Product/Process Change Notice (PCN)

PCN Number: PCN_FrqSPXO_20250219 Affected Series: WE-SPXO Affected Part Number: See table below PCN Date: 2024-11-19 (YYYY-MM-DD) Effective Date: 2025-02-19 (YYYY-MM-DD)	Change Category: <input type="checkbox"/> Equipment/Location <input checked="" type="checkbox"/> General Data <input type="checkbox"/> Material <input type="checkbox"/> Process <input type="checkbox"/> Product Design <input type="checkbox"/> Shipping/Packaging <input type="checkbox"/> Supplier <input type="checkbox"/> Software
Contact: Product Management Phone: +49 (0) 7942 - 945 5001 Fax: +49 (0) 7942 - 945 5179 E-Mail: pcn.eisos@we-online.com	Datasheet Change: <input checked="" type="checkbox"/> Yes <input type="checkbox"/> No Attachment: <input type="checkbox"/> Yes <input checked="" type="checkbox"/> No

Because of a database mismatch, Würth Elektronik eiSos will correct the RoHs status (1), packaging details (2), product dimensions (3), solder pad layout (4), IQD Part No. format (5), ageing (6), output compatibility (7), drive capability (8), duty cycle (9), environmental parameters (10), rise and fall time (11) and current draw (12) in the datasheet.

3. Correction of the Product Dimensions:

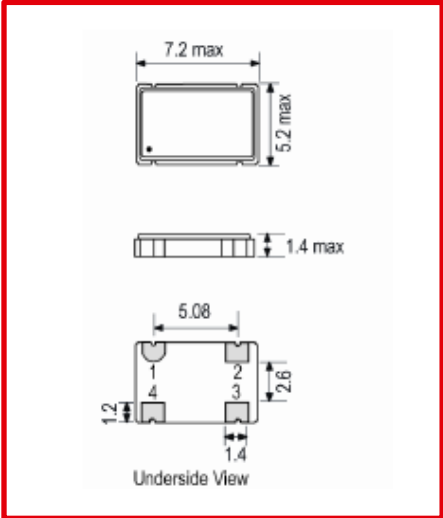
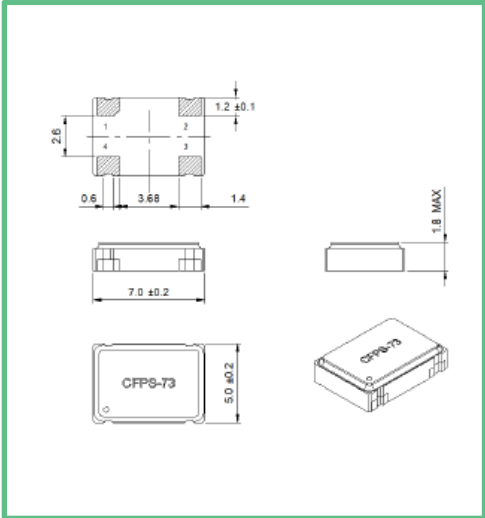
Before	After
Product Dimensions		
L	7.2 max	7.0 ± 0.2
W	5.2 max	5.0 ± 0.2
H	1.4 max	1.8 max

4. Correction of the Solder Pad Layout:

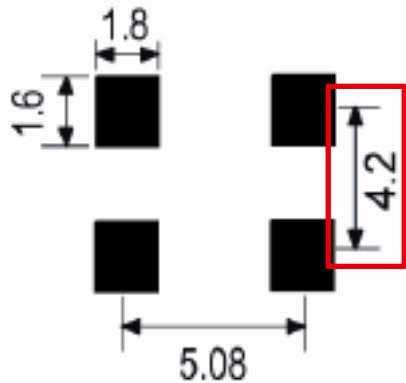
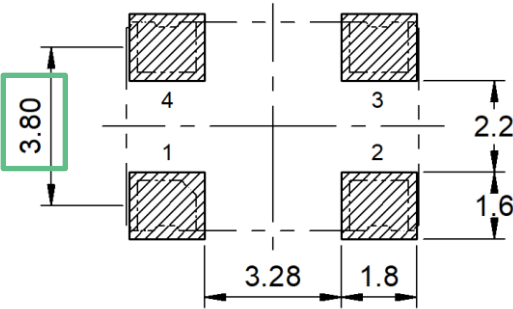
Before	After
Solder Pad Layout
